AXOD/AXODE (AX4S) UPDATE HANDBOOK

INTRODUCTION

*Updated
October, 2002*

Figure 48

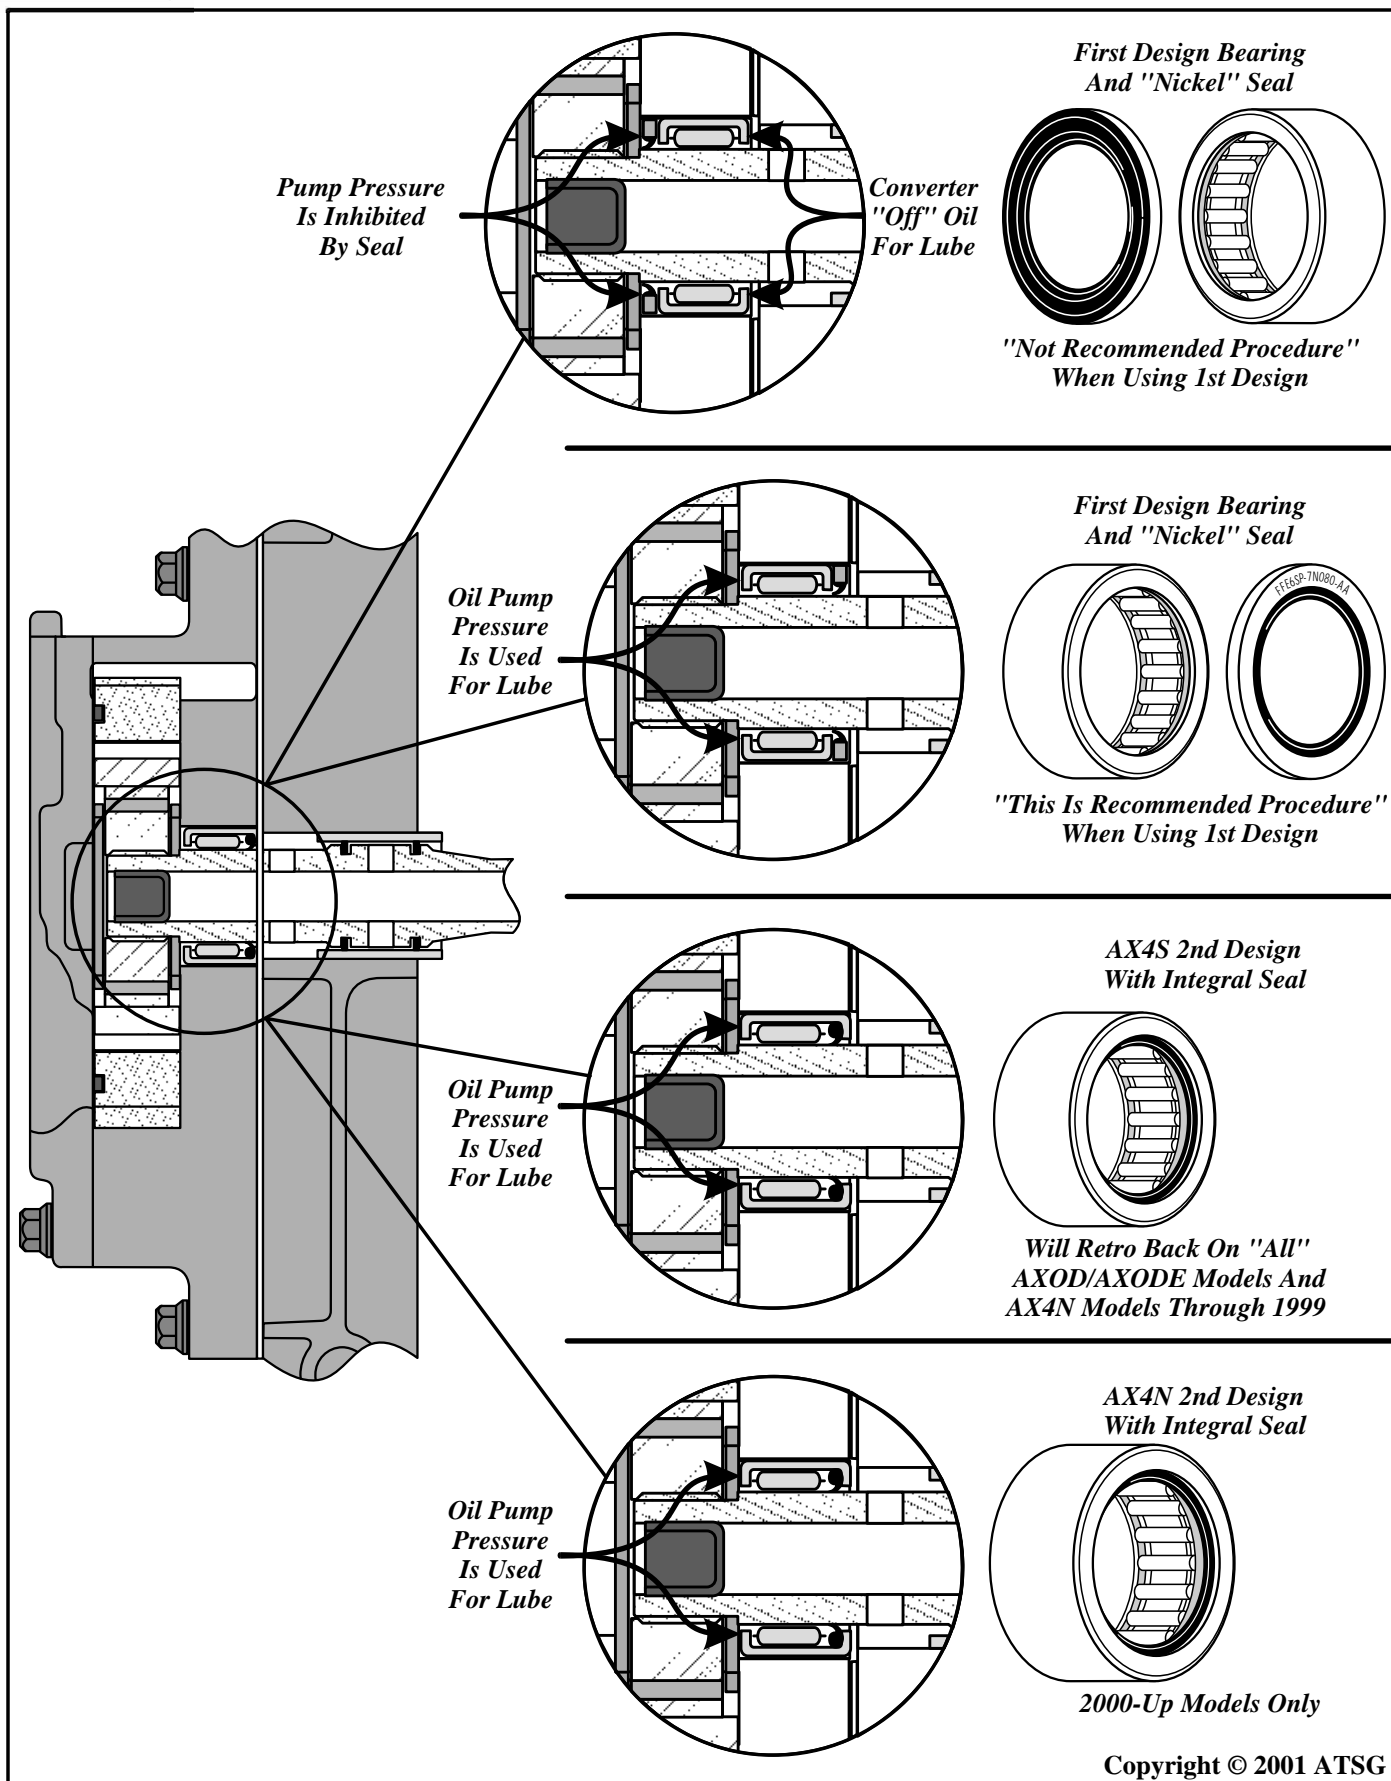
AXOD/AXODE (AX4S) - When using the 1st Design bearing with the "Nickel" Seal, install the seal on the valve body side, with the part number facing up, as shown in Figure 48. When using the 2nd Design bearing with the integrated seal, *which is recommended*, install the bearing assembly with the integrated seal facing the valve body side. The 2nd Design Bearing and Seal assembly *will retro-fit back on all* AXOD, AXODE and the AX4N up through 1999.

Figure 54

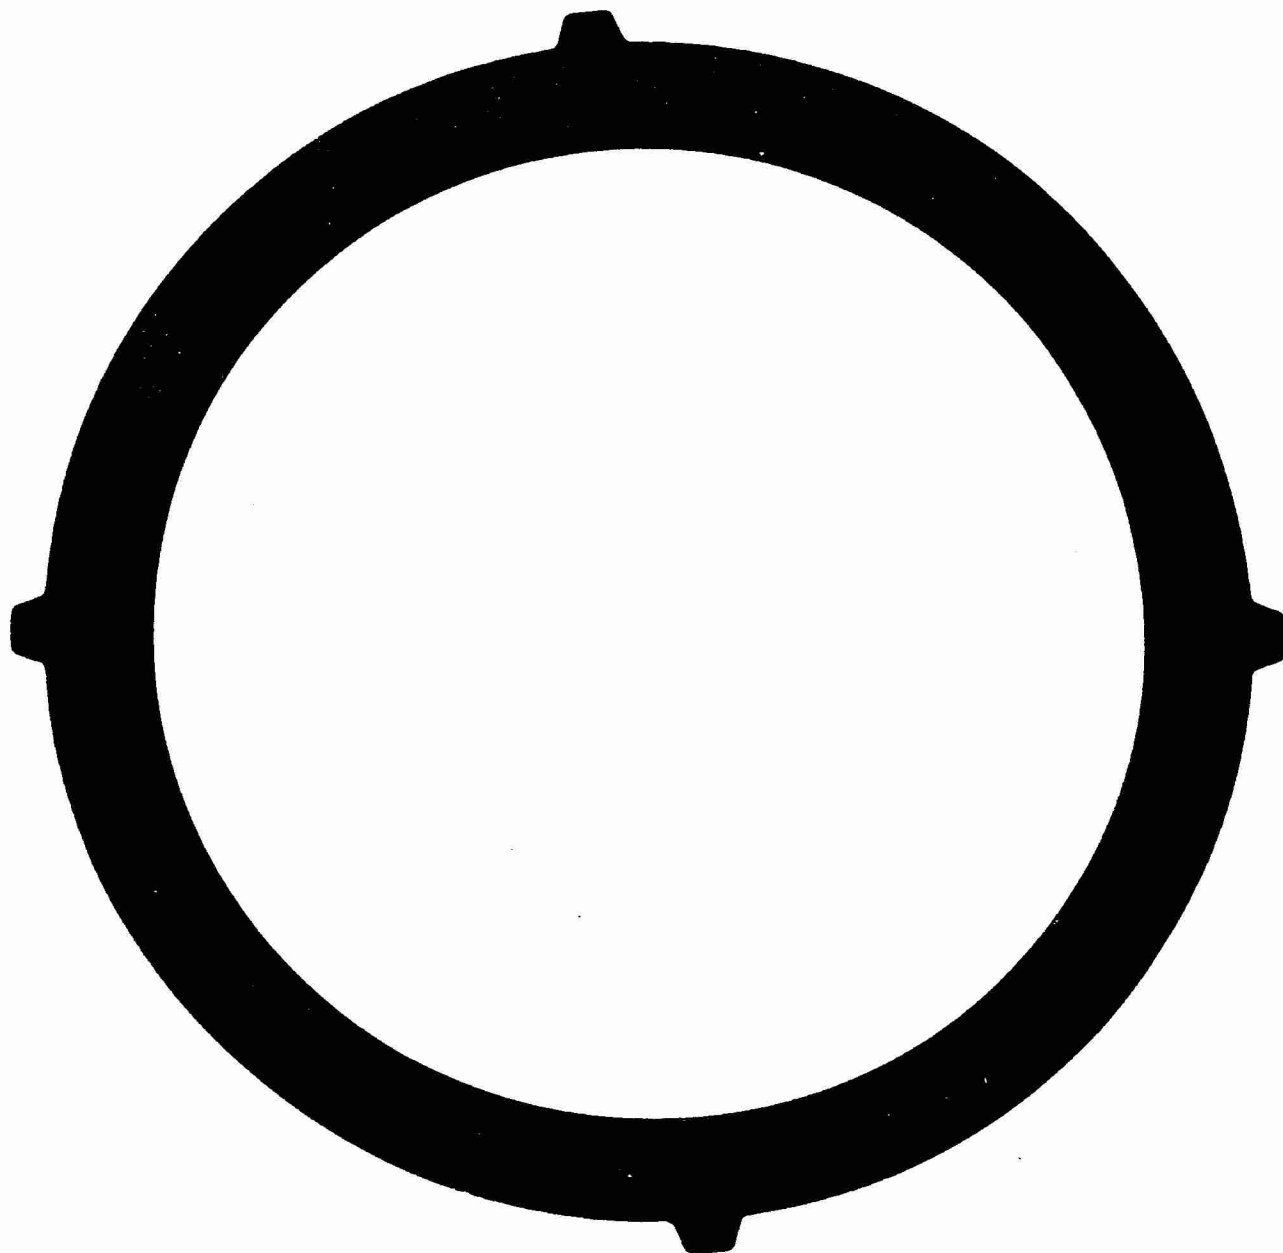
1ST DESIGN - Has 4 external teeth, an inside diameter of 4.715", material thickness of .062", and was used from 1986-1988. Refer to Figure 54.

Figure 55

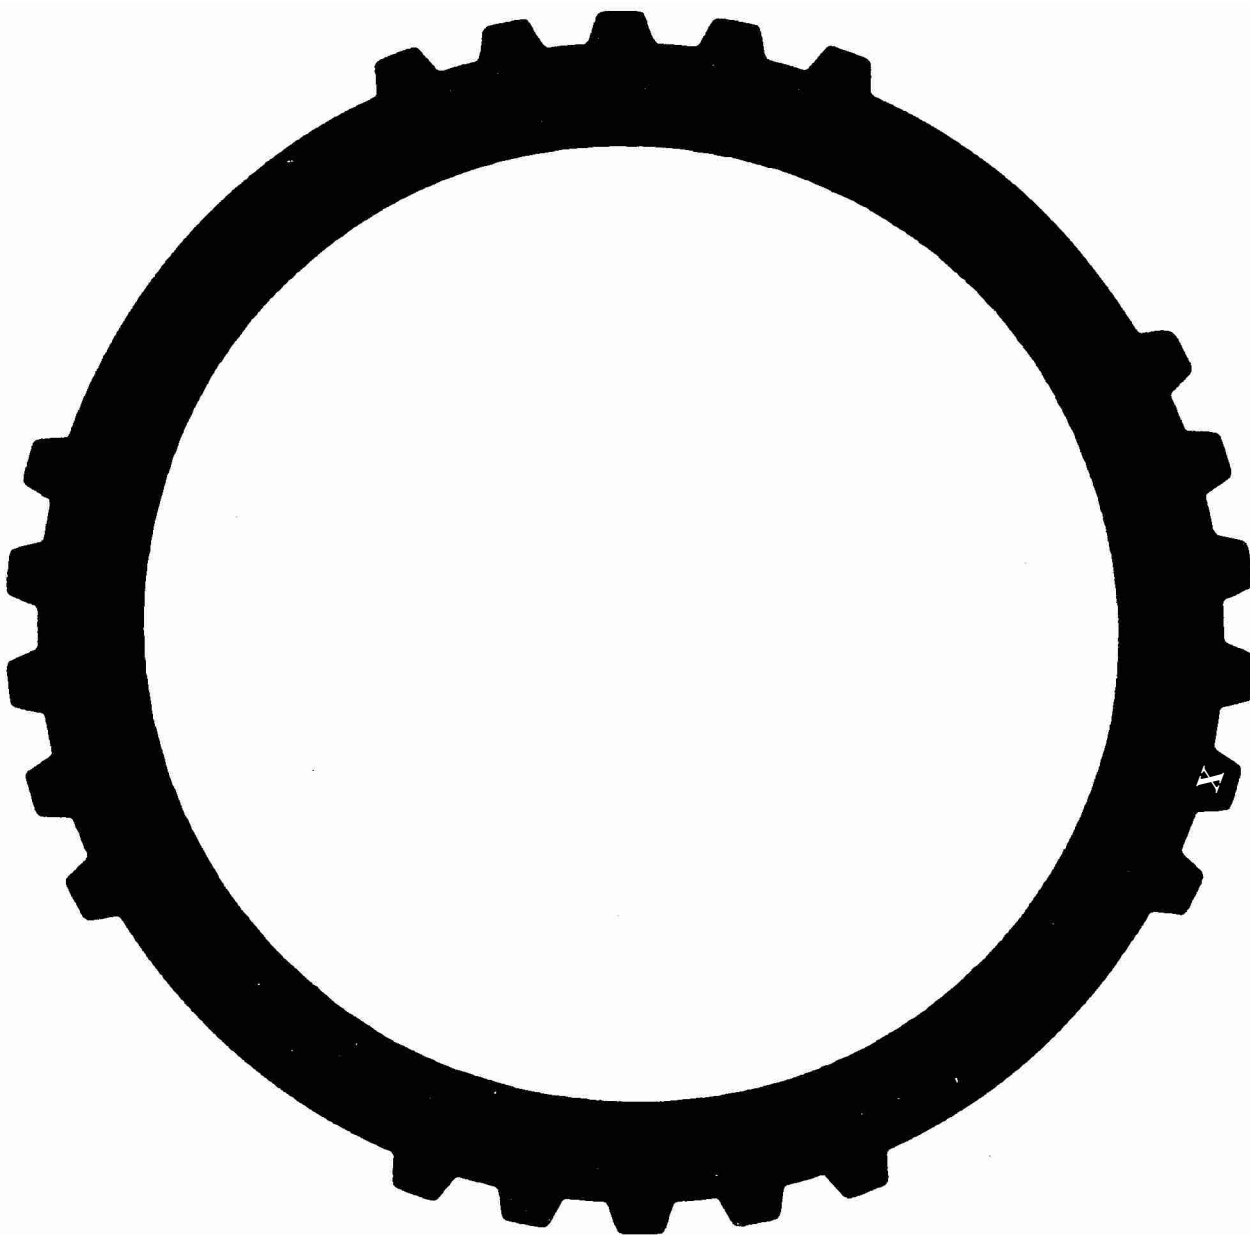
2ND DESIGN - Has 21 external teeth, inside diameter of 4.730", material thickness of .075", identified with letter "X" stamped on 1 tooth, and was used from 1989-1991. (See Figure 55).

Figure 56

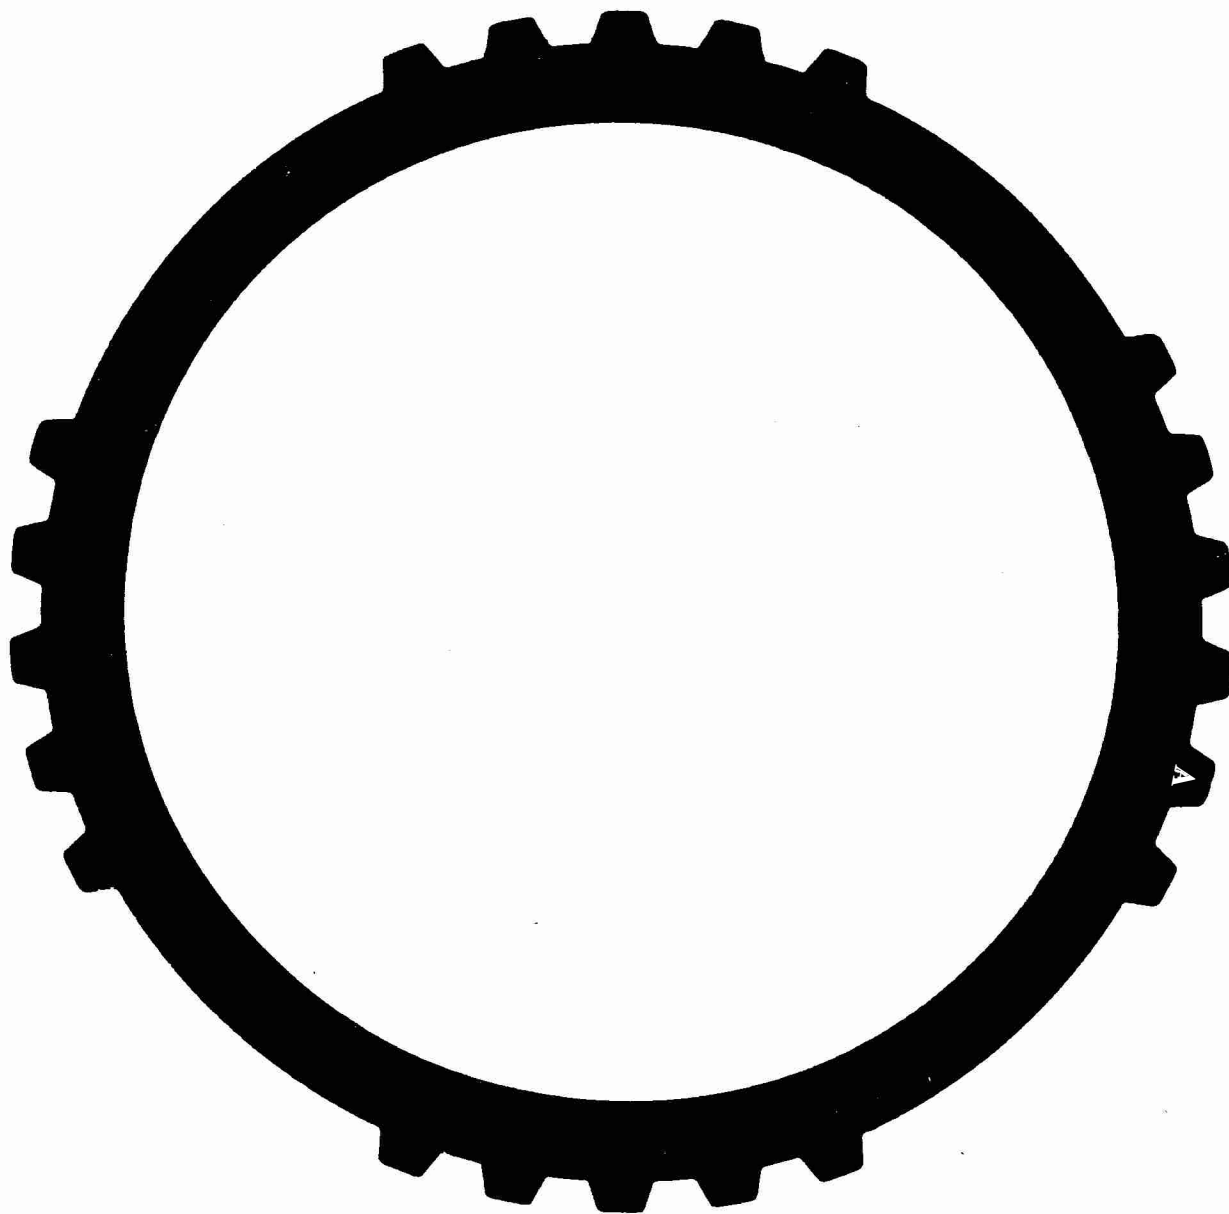
3RD DESIGN - Has 21 external teeth, inside diameter of 4.930", material thickness of .083", identified with letter "A" stamped on 1 tooth, used in 1992 and later models. (See Figure 56).

Figure 57

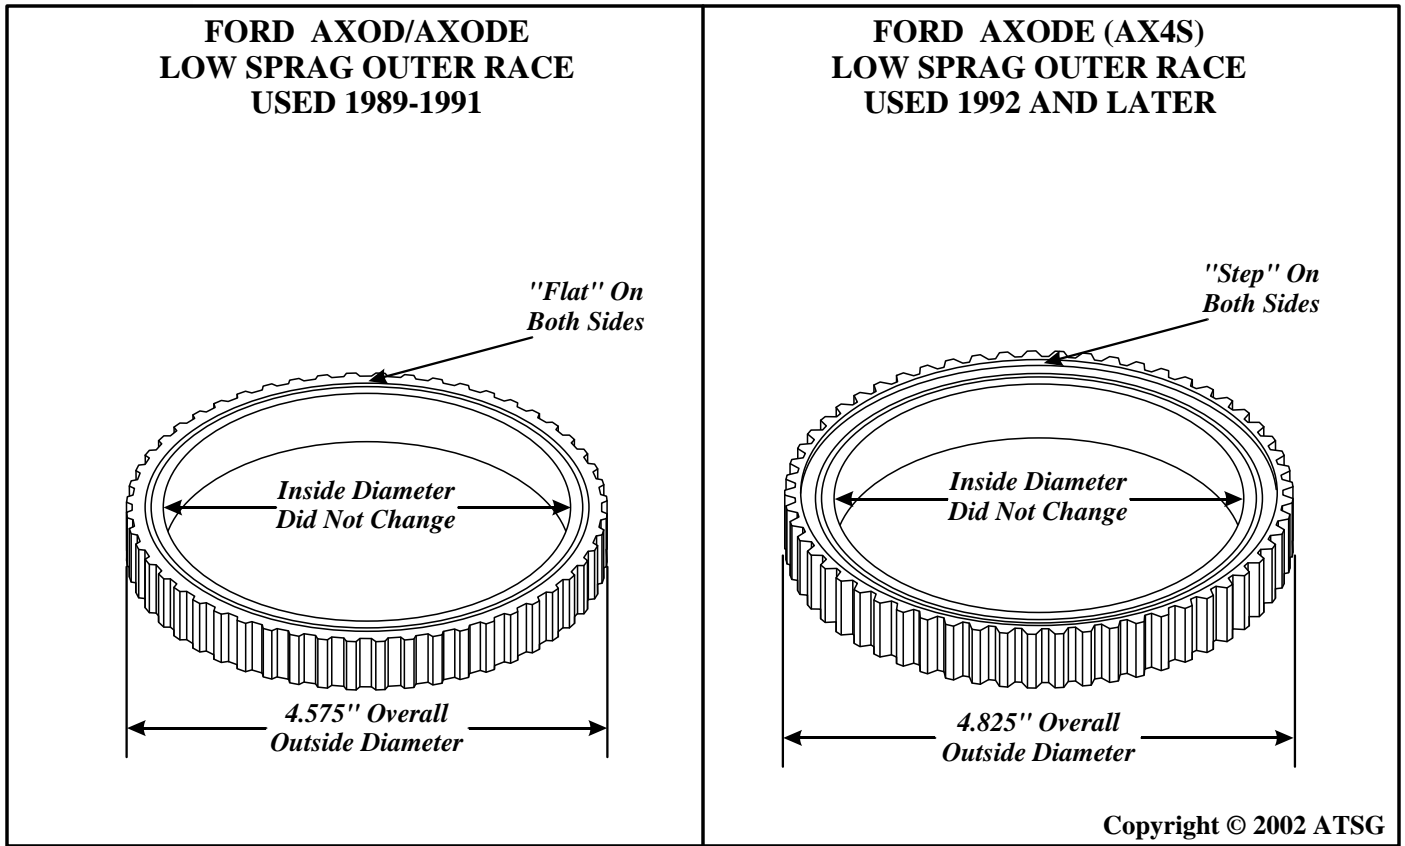
- (1) LOW SPRAG OUTER RACE - The outer diameter of the race was increased from 4.575" to 4.825", and the width of the race was increased from .600" to .725", as shown in Figure 57. *The Inside Diameter of the sprag race Did Not Change.*

Figure 58

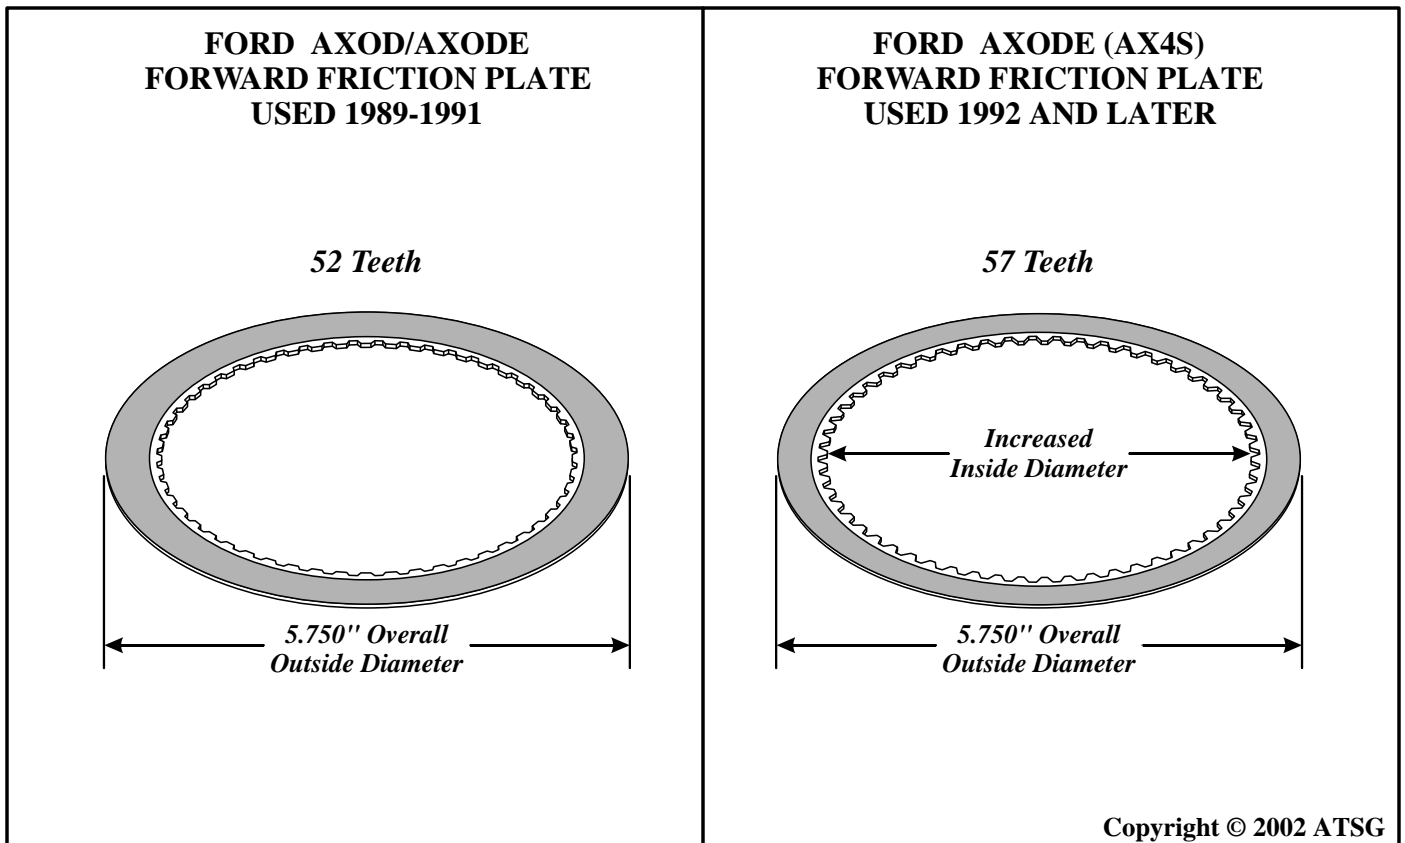
- (2) FORWARD CLUTCH FRICTION PLATES - Have an increased amount of teeth to 57 Teeth from the previous 52 Teeth, to accommodate the increased diameter of the sprag outer race, as shown in Figure 58.

Figure 59

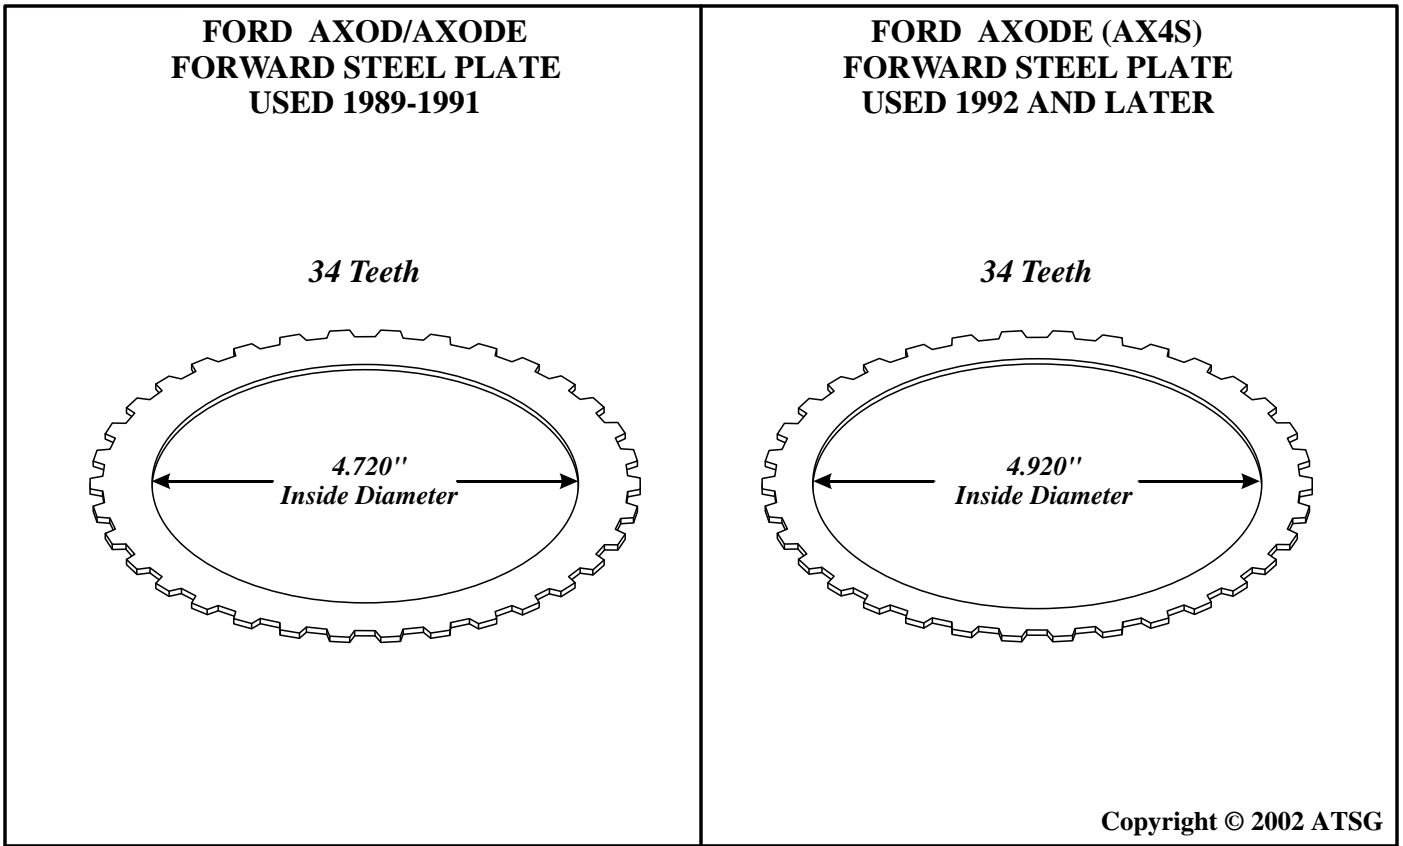
- (3) FORWARD CLUTCH STEEL PLATES - Have an increased inside diameter to 4.920" from the previous 4.720", to accommodate the increased diameter of the sprag outer race, as shown in Figure 59.
